Dodge® SCXT gear reducers: replacement of outdated models

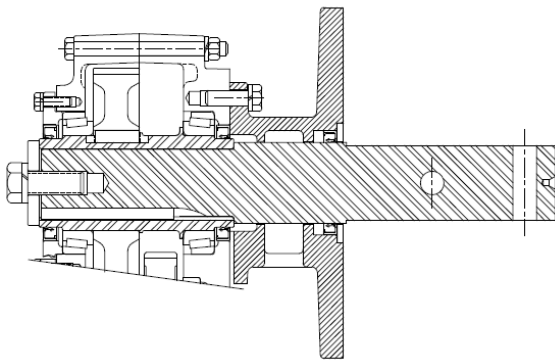
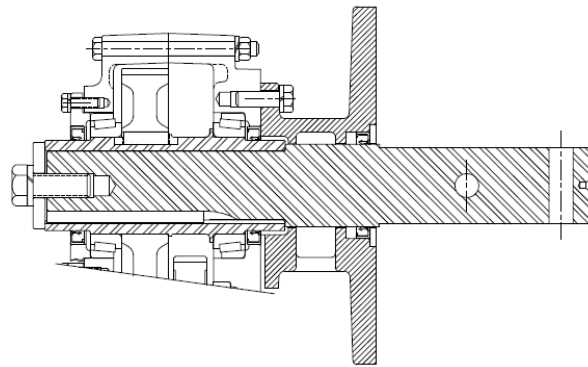
A frequent issue we encounter regards the replacement/interchange of older style SCXT size 3, 4 and 5/5A reducers with the current version SCXT 3B, 4B, and 5C reducers. The common observation is that the output hub on the new reducer extends out from the face of the housing where the old style reducer output hub was flush with the housing. See below:

SCXT sizes 3, 4, and 5 were changed in the early 1990's to use the same output hub as the TXT size 3, 4, and 5 straight bore shaft mount reducers. This change required a redesign of the drive shafts for these sizes. **The current model reducers are NOT compatible with the drive shafts from the older SCXT 3, 4, and 5/5A models.**

When replacing older SCXT size 3, 4, and 5 or 5A reducers, **the drive shaft MUST also be replaced for the reducer to fit and install properly.** SCXT reducer output hubs in sizes 1, 2, 6, 7, and 8 have not been changed and there has been no redesign of the drive shafts in these sizes.

SCXT New style reducer installed on older drive shaft

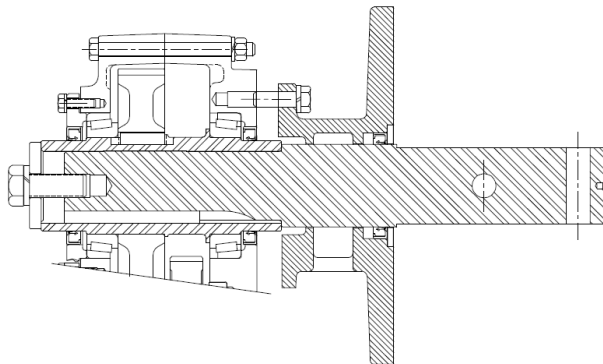
What usually happens is the customer removes the older style reducer from the screw conveyor while leaving the adapter assembly and drive shaft in place. They attempt to install the new reducer on to the old drive shaft, but the extended output hub hits the shoulder on the drive shaft, leaving a gap between the reducer and the adapter assembly.

C / AC Adapter – new style

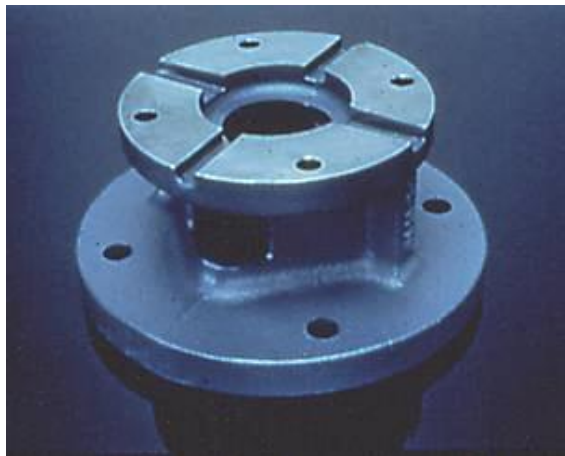
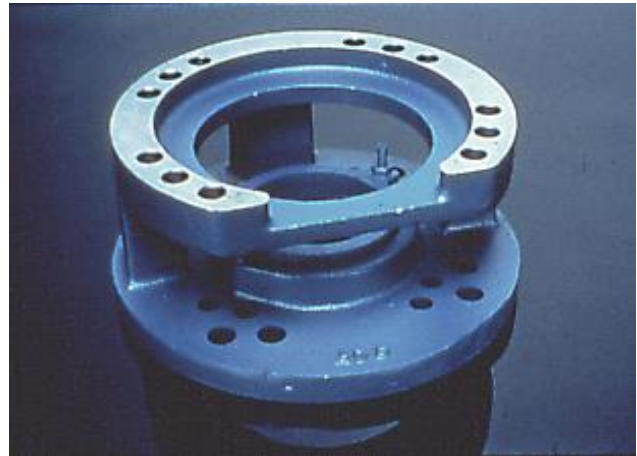
Another frequently asked question involves the adapter assembly. The adapters were changed in 2003 to a design with cast slots instead of drilled holes to fit bolt pattern of the screw conveyor trough end plate, and the adjustable packing adapter has been incorporated into the standard design, there is no need for a separate AC adapter assembly when using the adjustable packing seal kit.

Also, the bore of the C1A Adapter Assembly has been opened up to allow this adapter to be used with all four C1 drive shaft diameters - C1 x 1-1/2", C1 x 2", C1 x 2-7/16" and C1 x 3". There will then be no need to offer the C1B Adapter Assembly. This also applies to the C2A and C2B Adapter Assemblies: the C2A is the only one available for sale, and the C2B has been discontinued. This revision has reduced customer inventory - a beneficial change for our customers.
